Access Compliance Report

Public Rights-of-Way

(Pedestrian Signals)

Intersection ID: N/A	Main Street:	Cross Street: N/A	Location: N/A
ADA ID: 2A2118431533	Signal Type: Two Push Buttons-APS	Overall Compliance: No	Severity Score: BTN 1:N/A BTN 2: N/A No BTN: N/A
Codes/Mitigation Info/Possible Solution		Field Measurements/Component Compliance

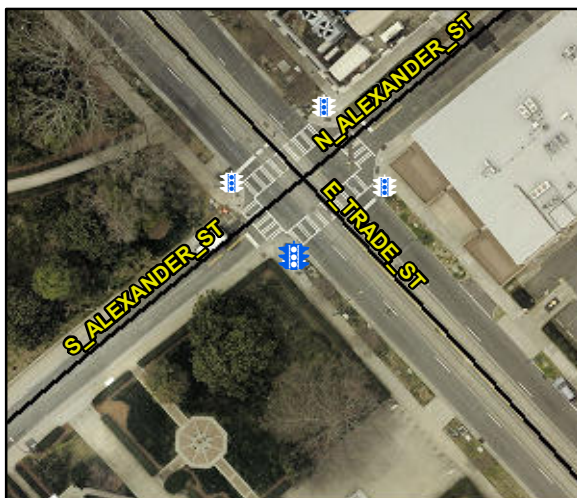
Possible Solutions: Remove & Replace
Replace APS Button With New APS Button.
Remove and Replace Clear Space. Replace
Signal Push Button With APS Button on New
Post. Remove & Replace Sign.

Surveyor Notes: TEXT HT 1/4

PROW/ADA: R410.6, R404.2, R404.3, R406.2, ,
TMUTCD 4e.08
